# BARBARICK RECYCLING AND REFUSE TRANSFER STATION

CONSTRUCTION DOCUMENTS  
MARCH 2024

BARBARICK WASTE TRANSFER STATION  
EL PASO COUNTY, COLORADO  
CONSTRUCTION DOCUMENTS  
COVER SHEET

BARBARICK WASTE TRANSFER STATION  
EL PASO COUNTY, COLORADO  
CONSTRUCTION DOCUMENTS  
STORM PLAN & PROFILE

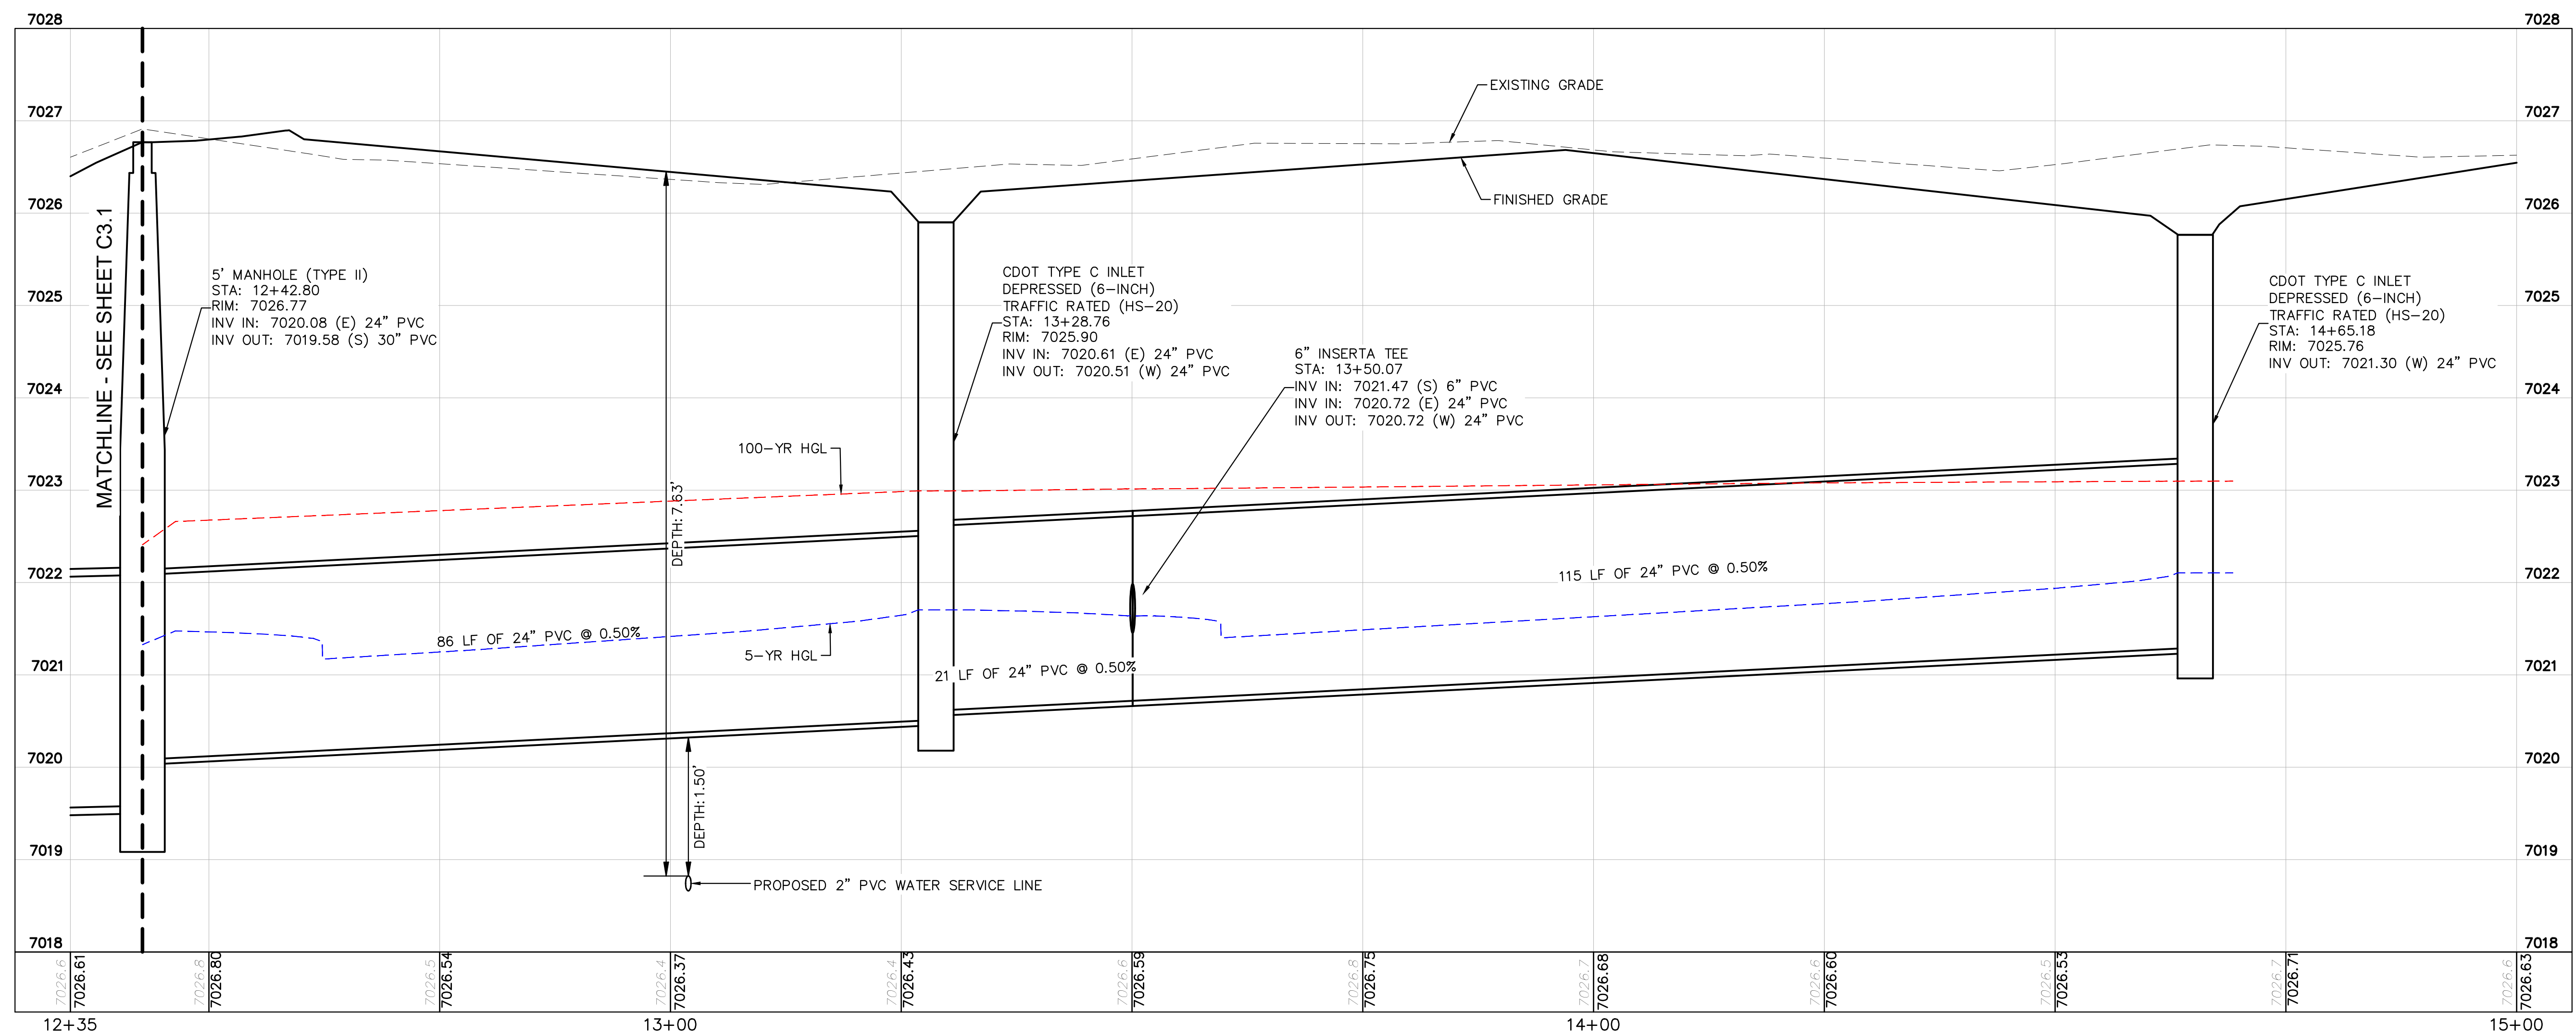
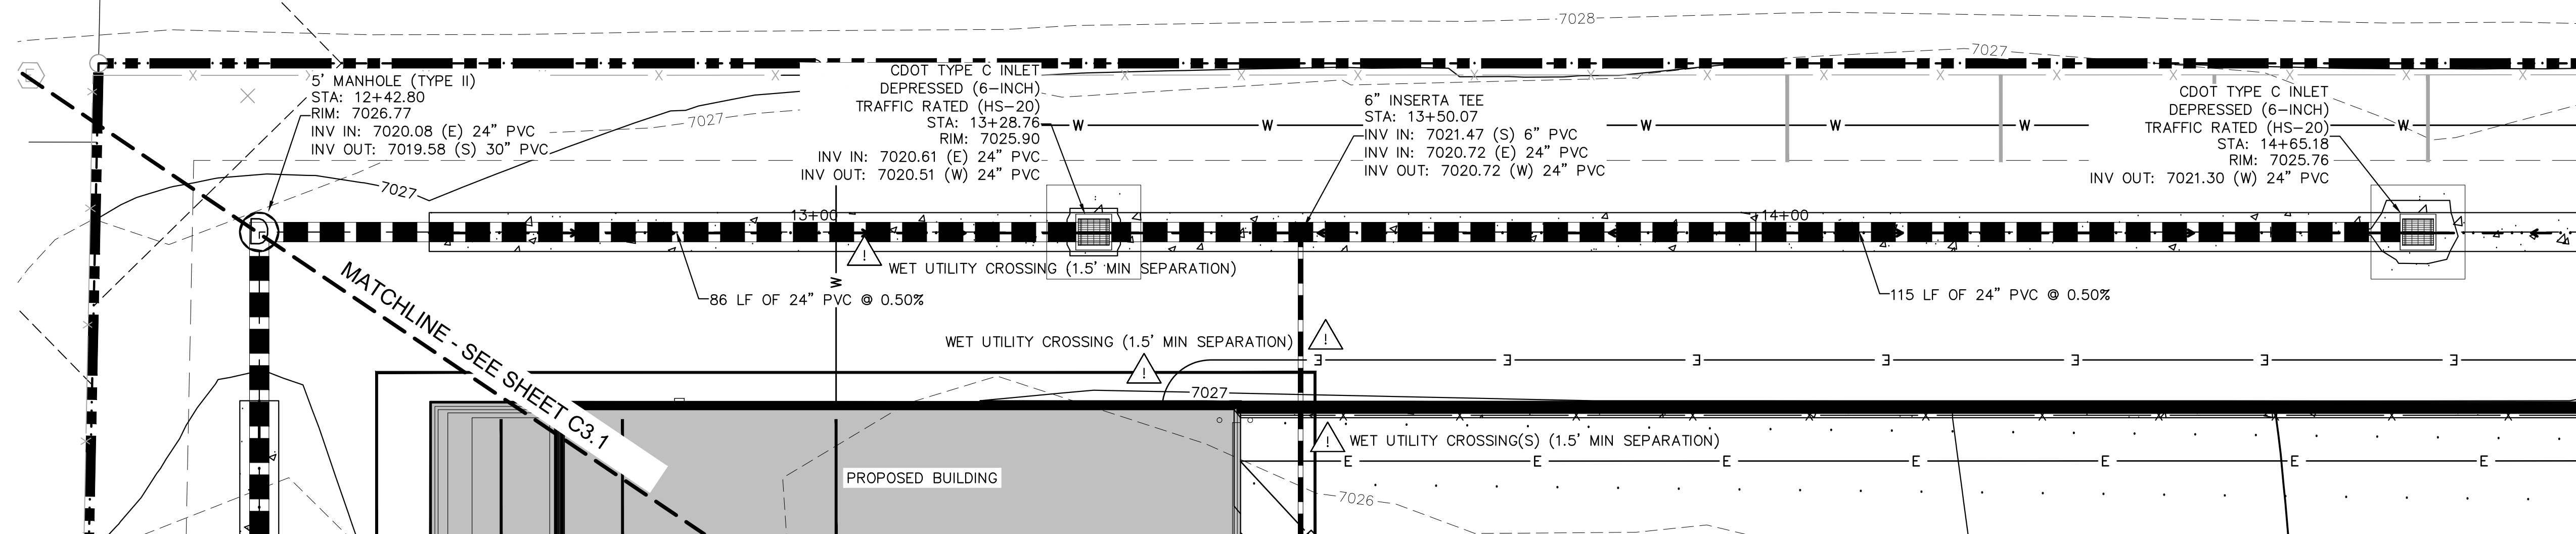
Please add the following note to the CD where applicable  
"Add water tight joint when 100 YR HGL shows pipe fully inundated"

KH Response:  
Addressed

BARBARICK WASTE TRANSFER STATION  
EL PASO COUNTY, COLORADO  
CONSTRUCTION DOCUMENTS  
STORM PLAN & PROFILE

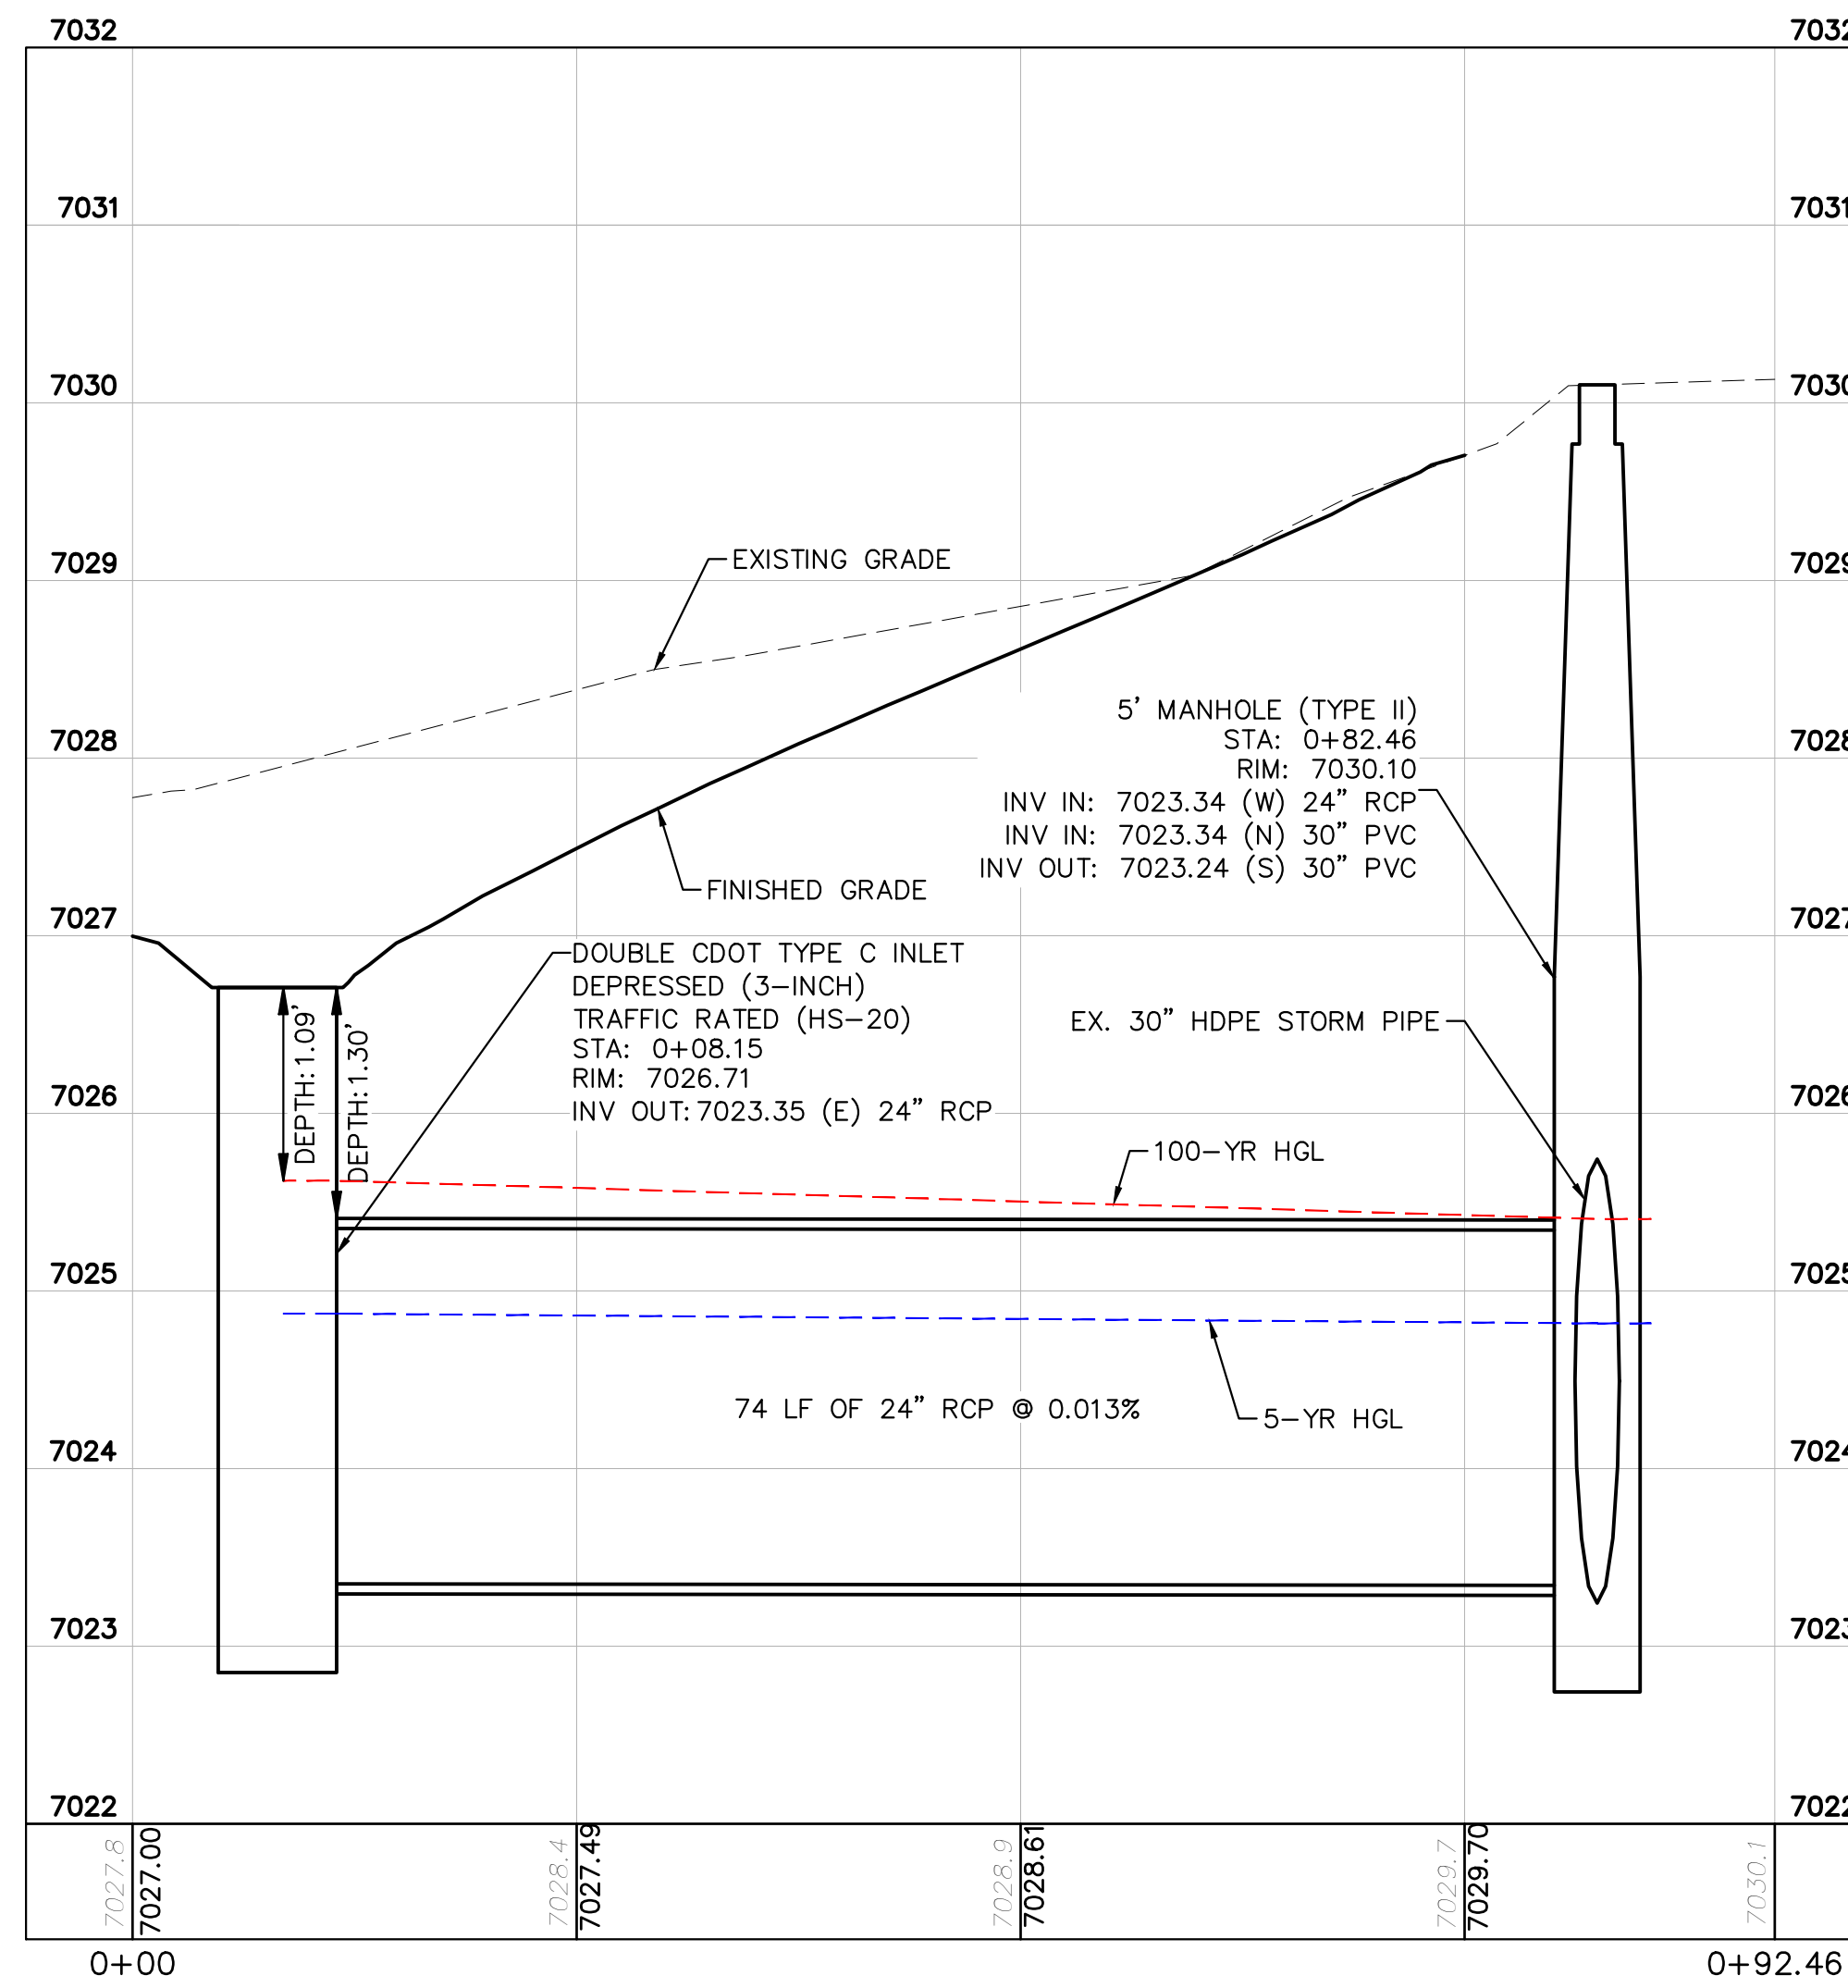
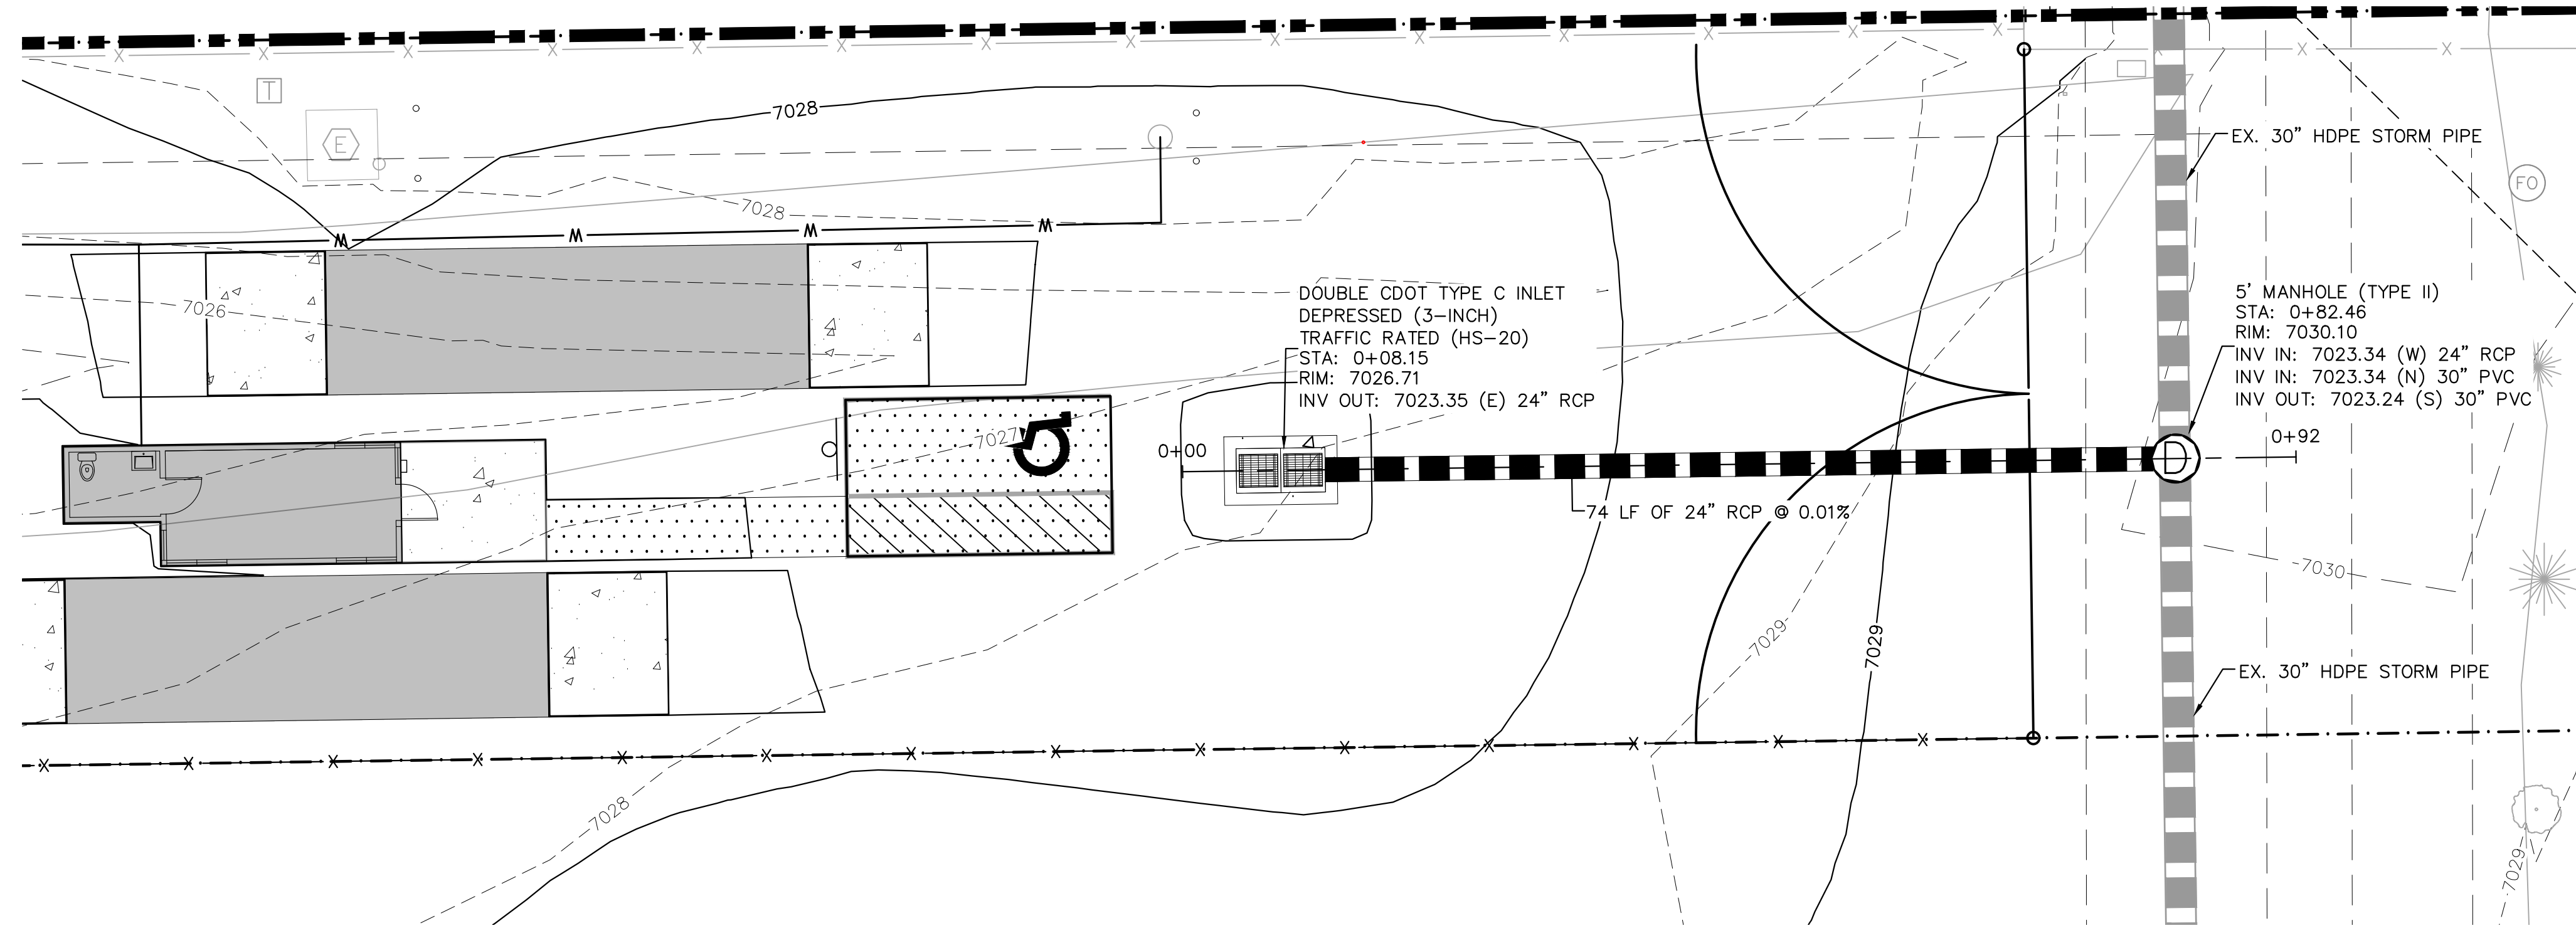
Please add the following note to the CD where applicable "Add water tight joint when 100 YR HGL shows pipe fully inundated"

KH Response: Addressed
